August 15, 2025

USD 321 Rossville High School Addition and CTE Renovation – JGR Proj #22-3269

ADDENDUM NO. 1

SITE DEMOLITION NOTES

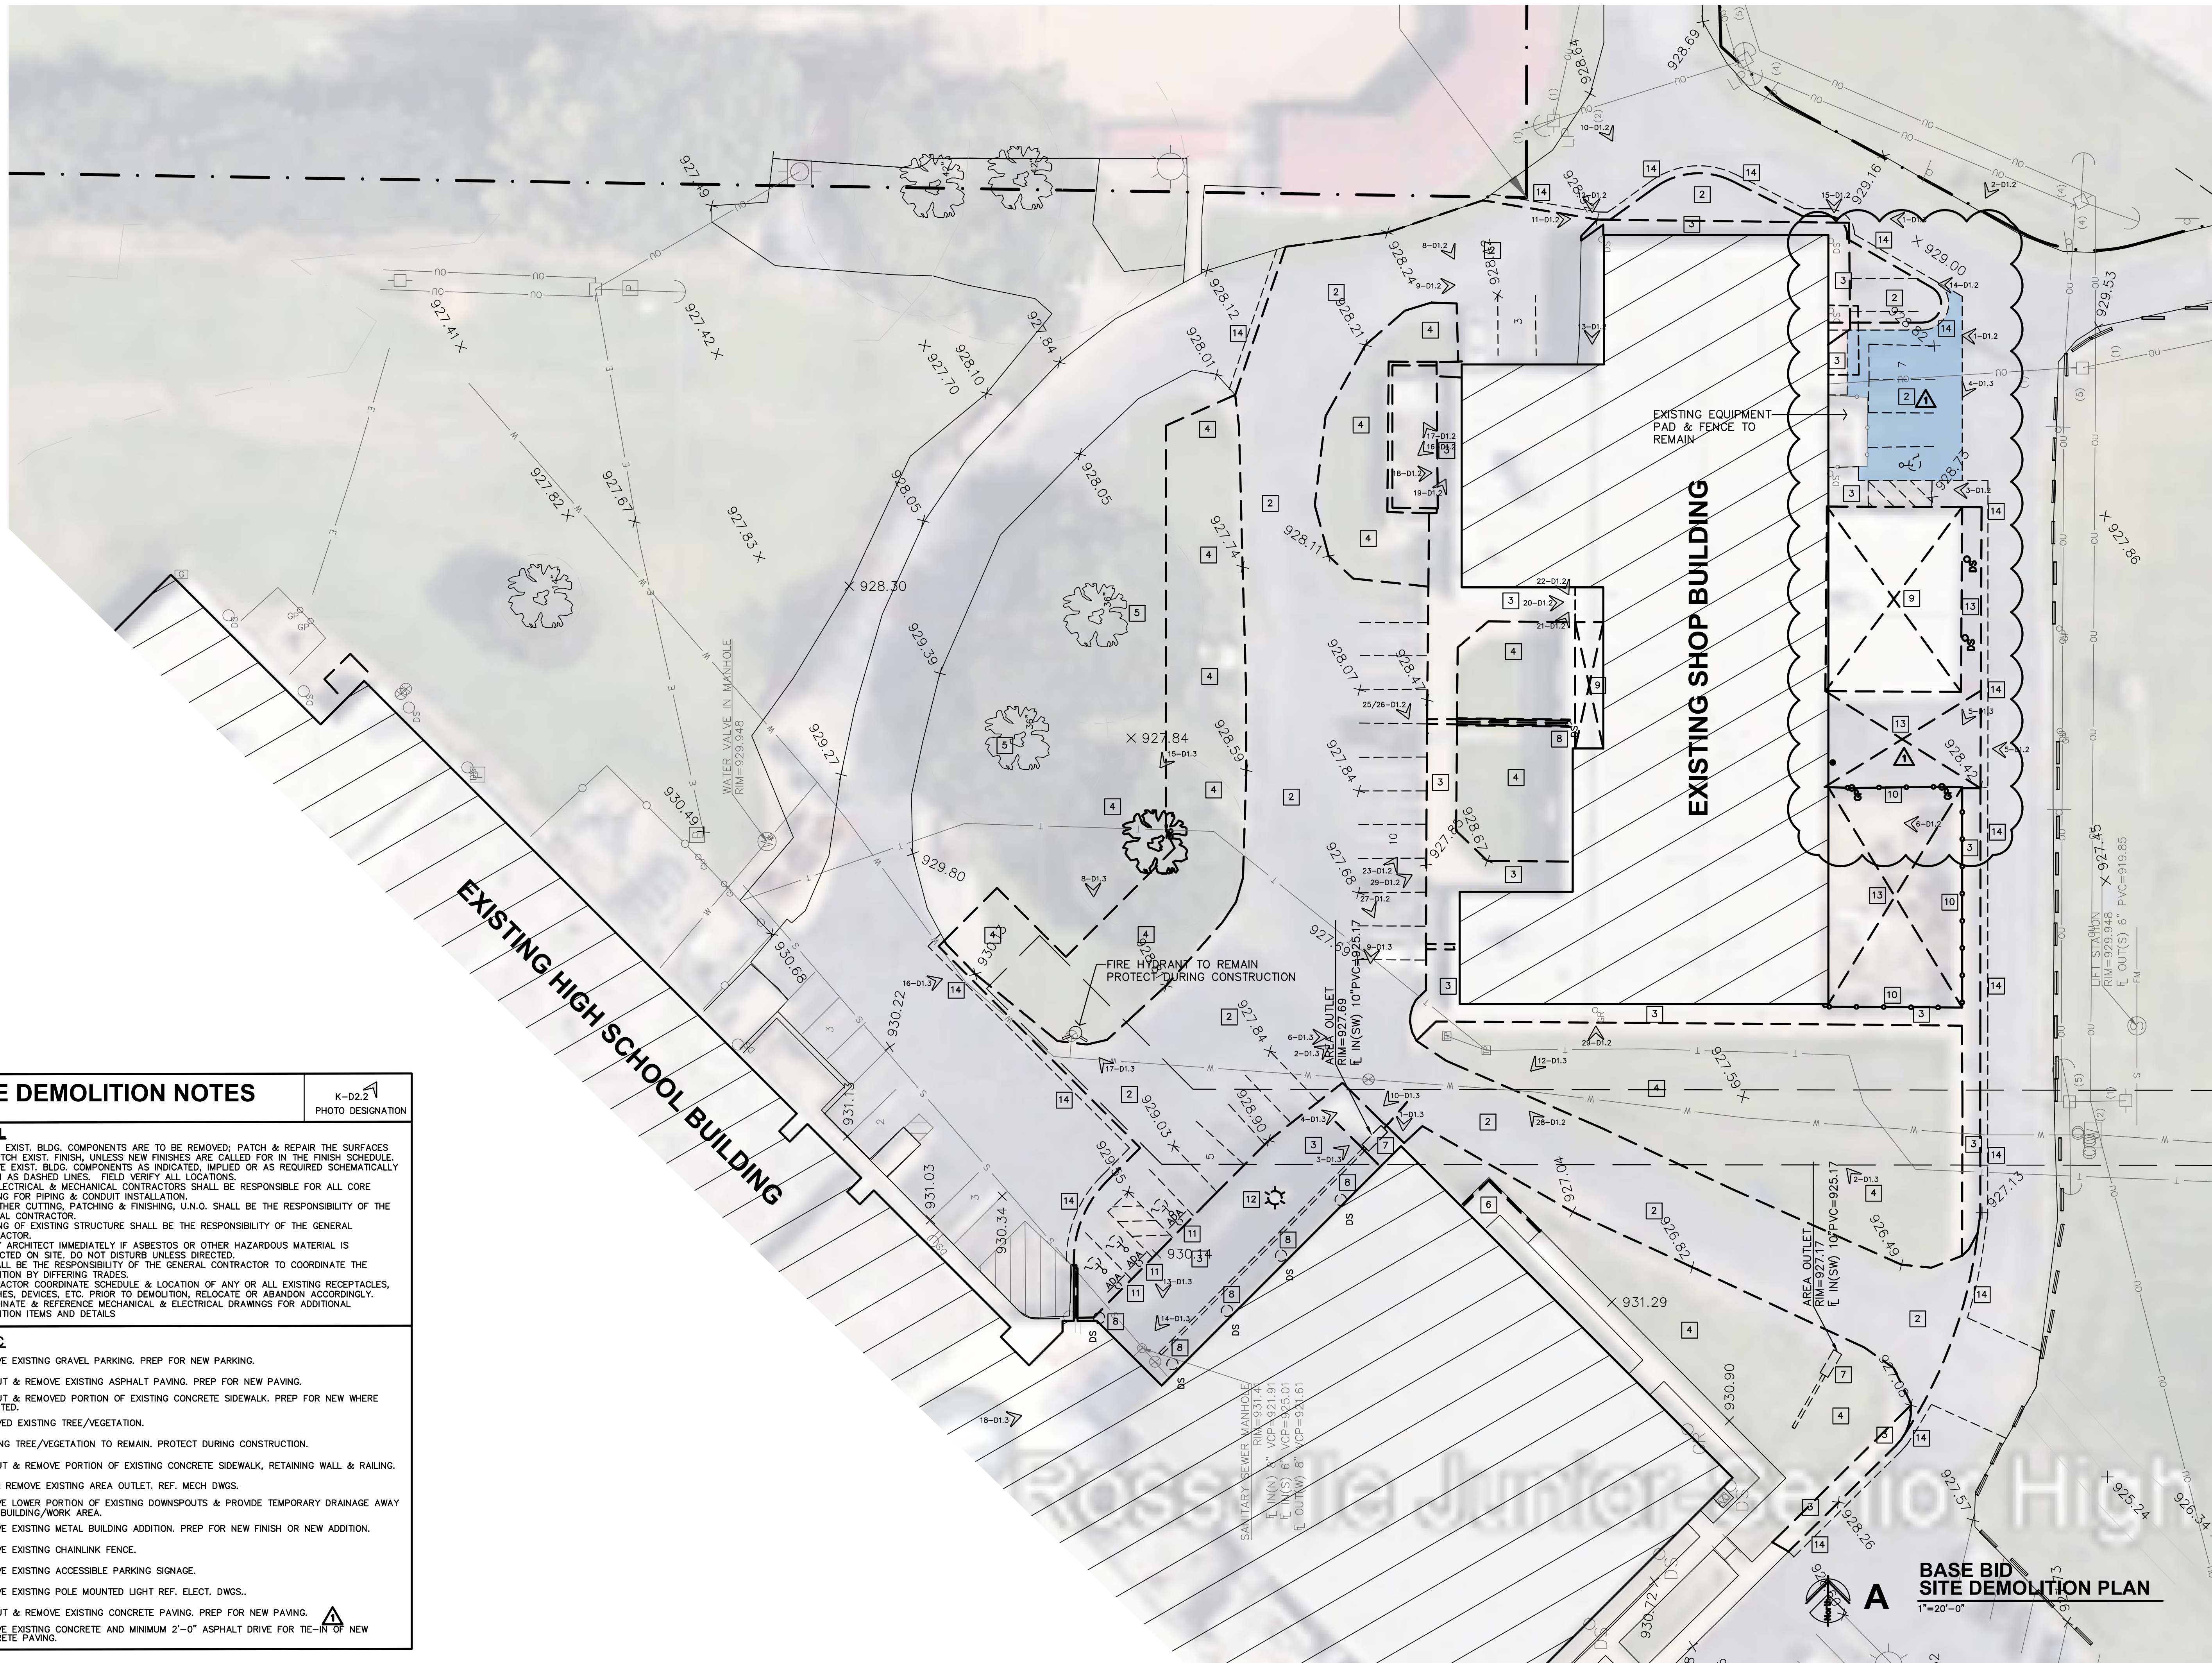
2. Sheet A1.0 and D1.0 Site Plan and Demolition Site Plan: Reference the attached sheets A1.0 and D1.0 for clarification regarding the extent of site paving demolition and installation of new paving at the east side of the CTE building.

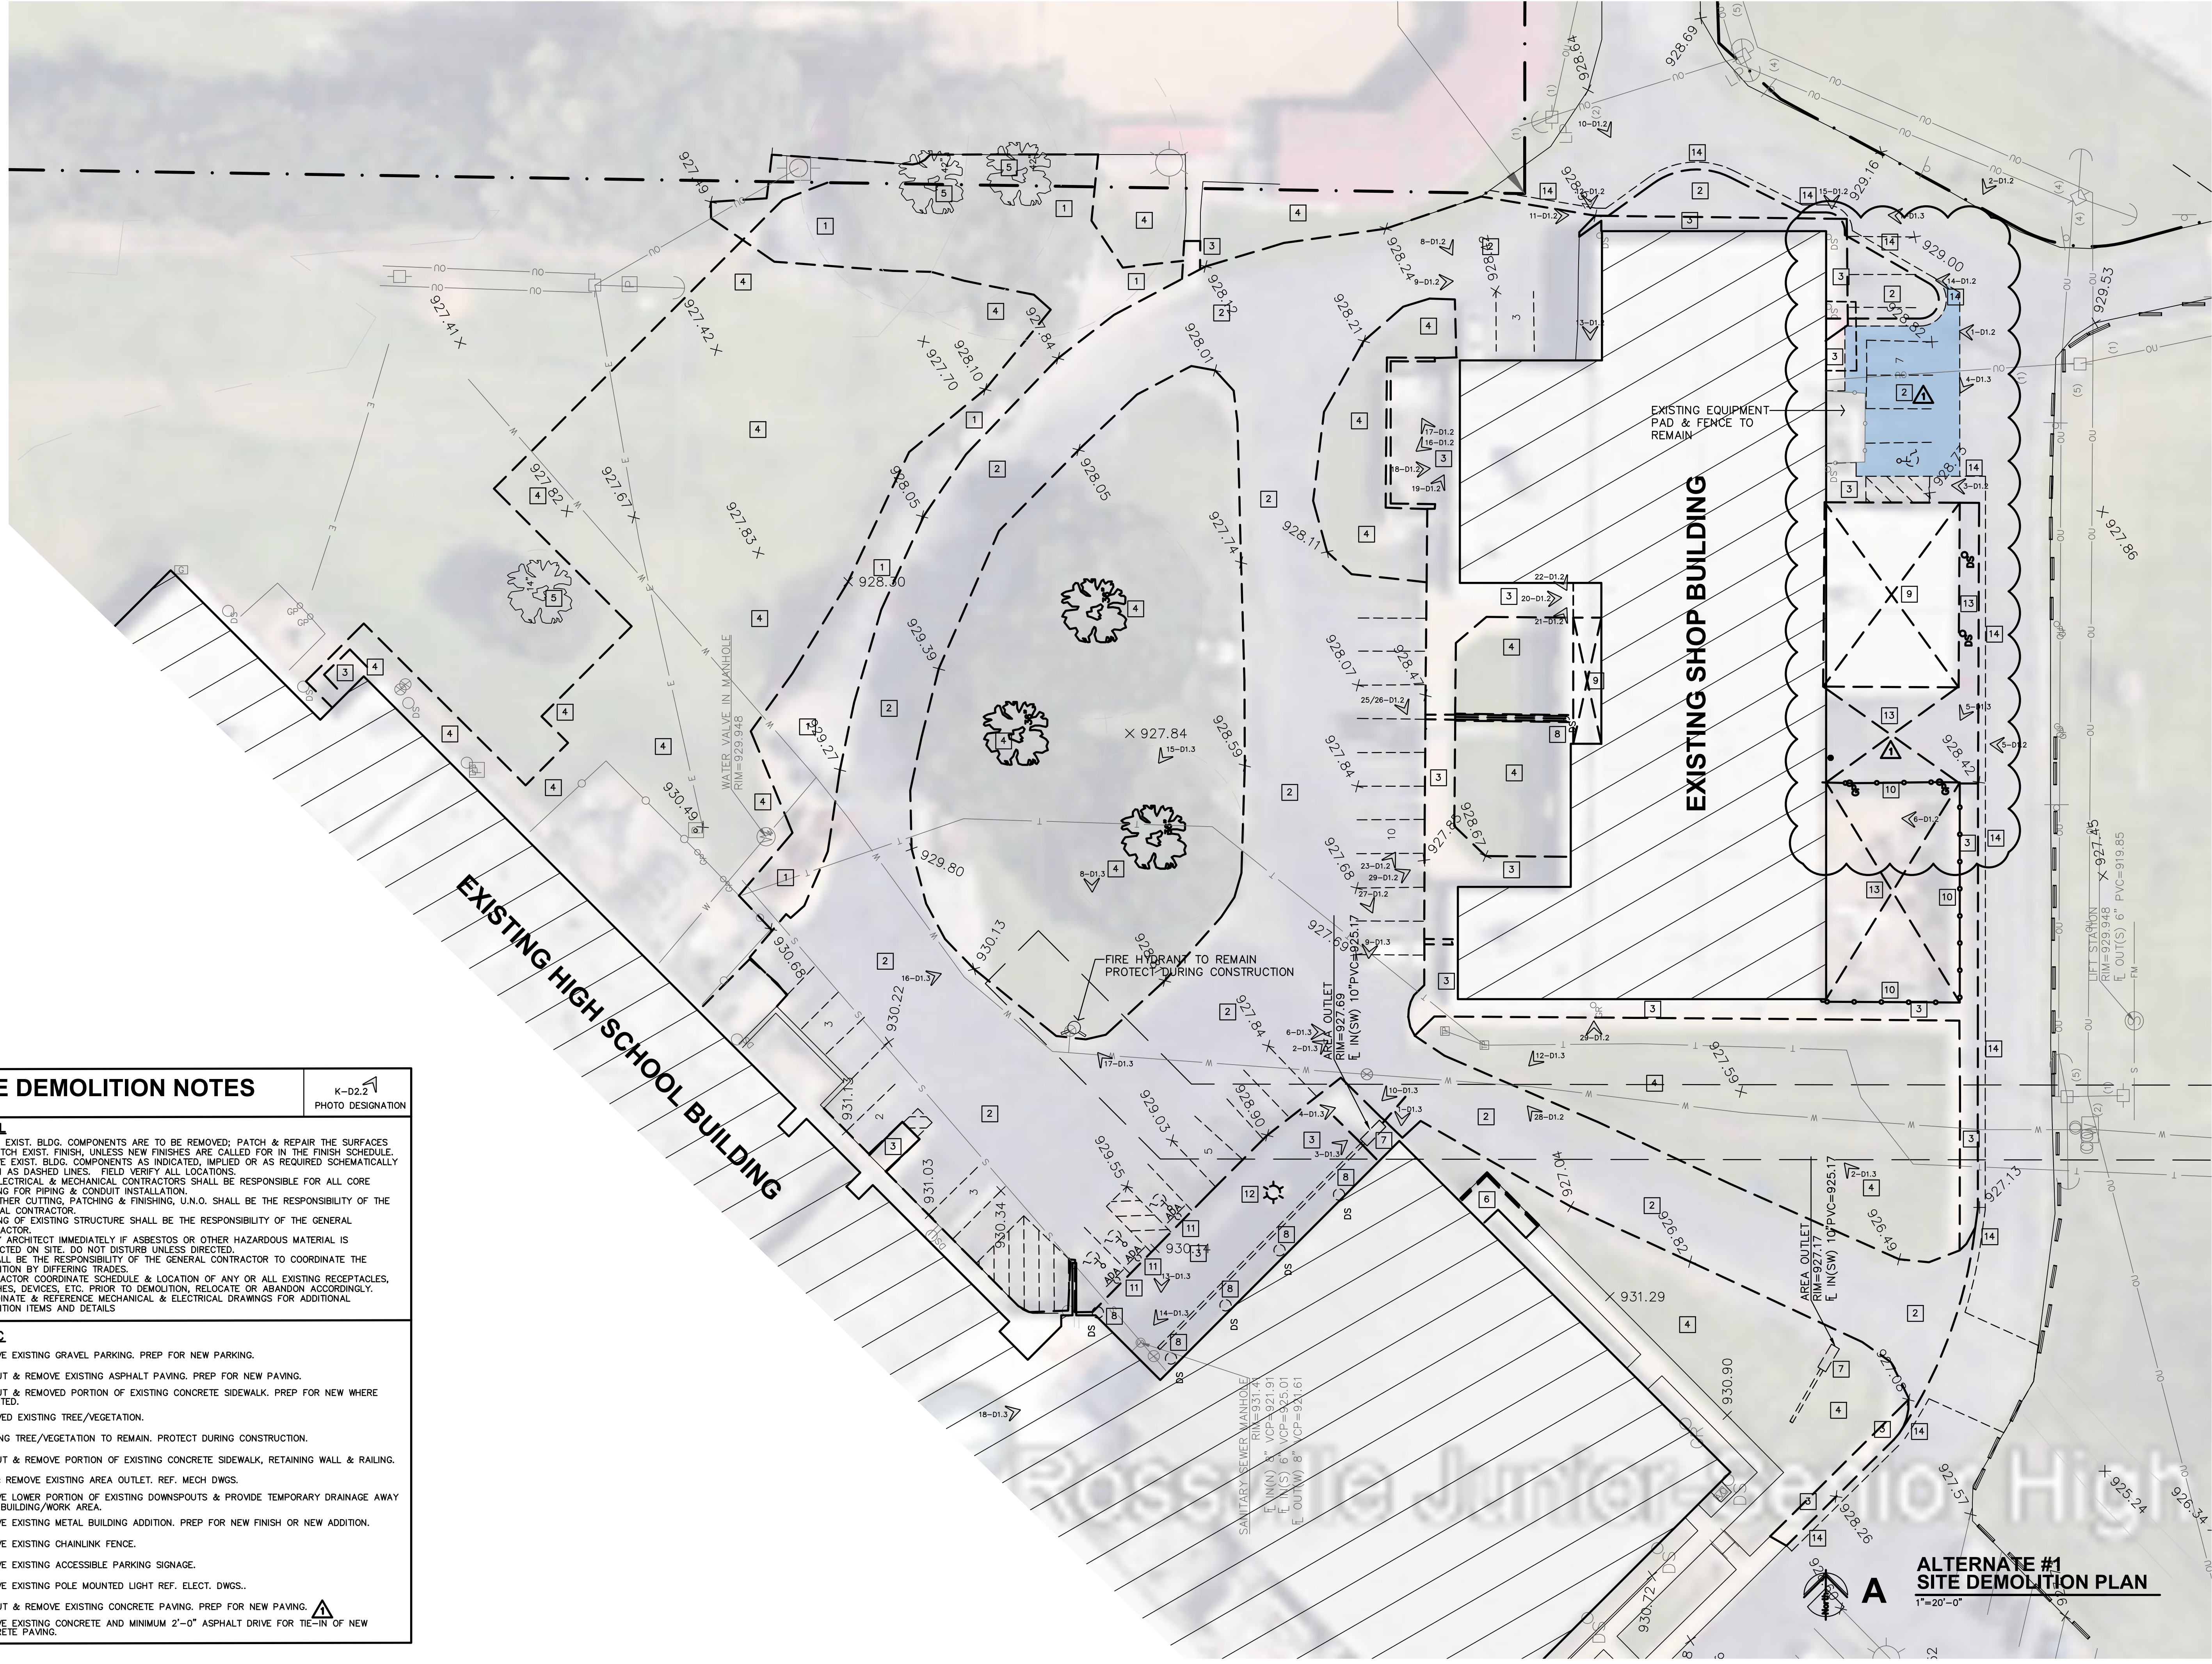
1. Sheet A1.0 Site Plan: At the south outdoor storage fence area. The gate access shall consist of a 10' sliding gate at the west leaf, and a 10' swing gate at the east leaf. Both gates shall include wheel/casters to support for smooth operation of the gate. Provide vertical post latch and concrete sleeve at gate ends for securing gate in close position.

3. Sheet A1.0 and A2.0 Site and Floor Plans: A revised handicap sidewalk curb ramp, and handicap sidewalk to the center entrance is added. Reference the attached sheets A1.0 and A2.0.

FENCE TYPE 1
CHAINLINK FENCE ELEVATION
1/2"=1'-0"

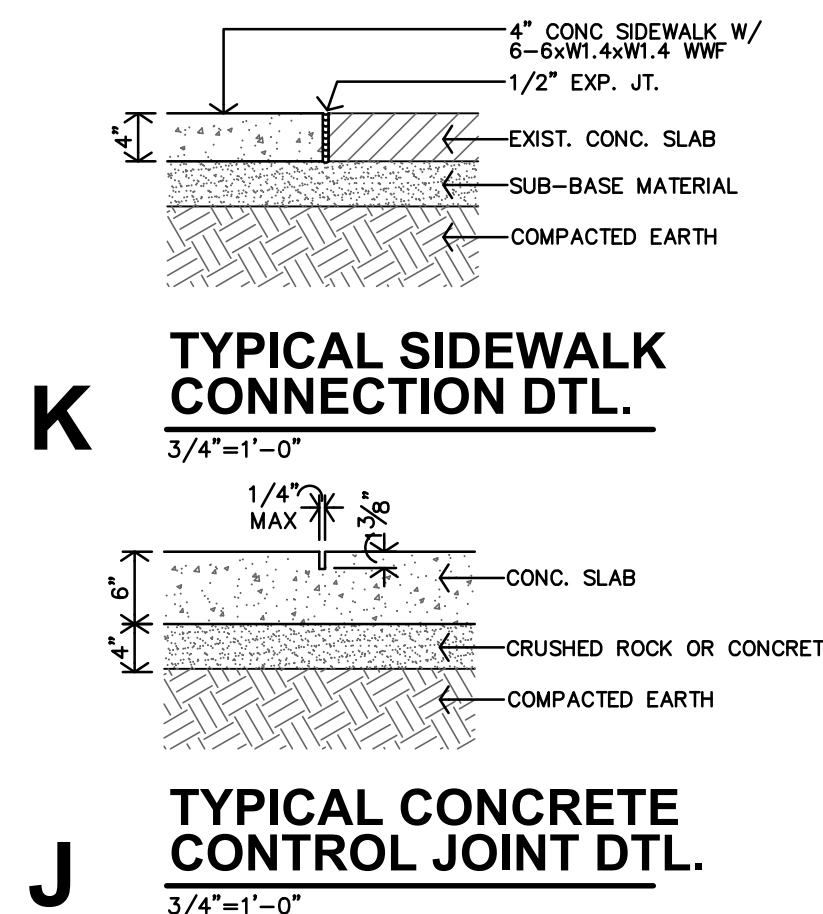
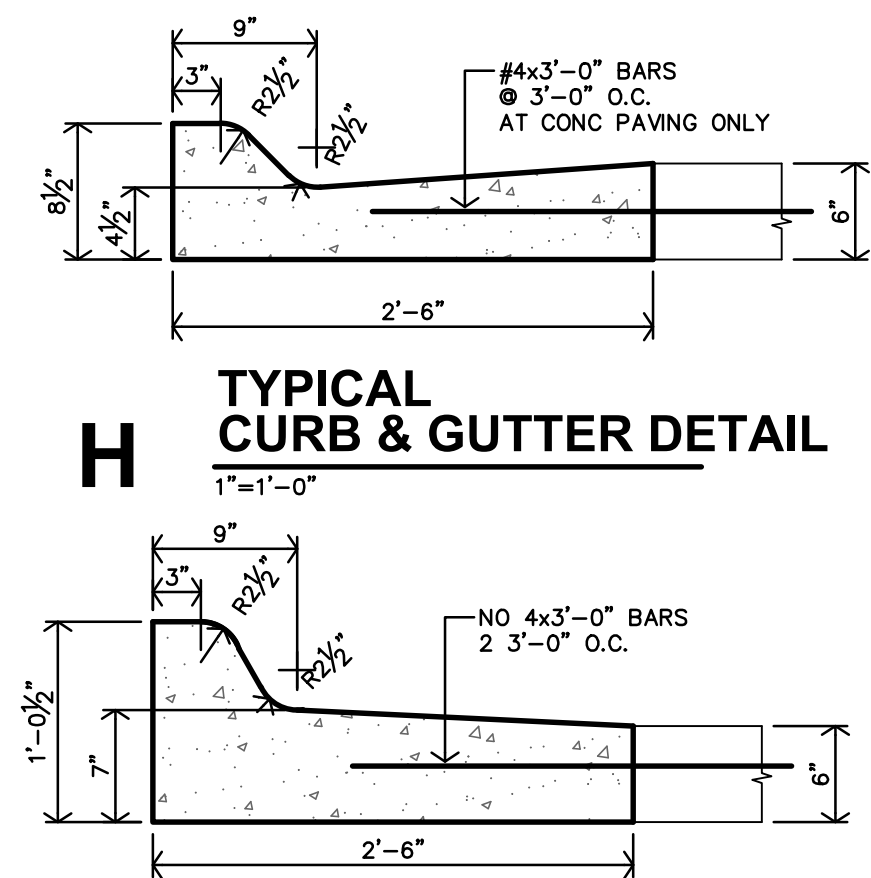
4. Sheet A1.1 Site Plan: At the south outdoor storage fence area. Fence is to be Type 2, 8' tall.
5. Sheet A1.3 Detail L Chain Link Fence Details: Fence Type 1, located at the Art Patio Base Bid, is to be Black Polyolefin Coated type per spec section 02831 Plastic Coated Chain Link Fence.
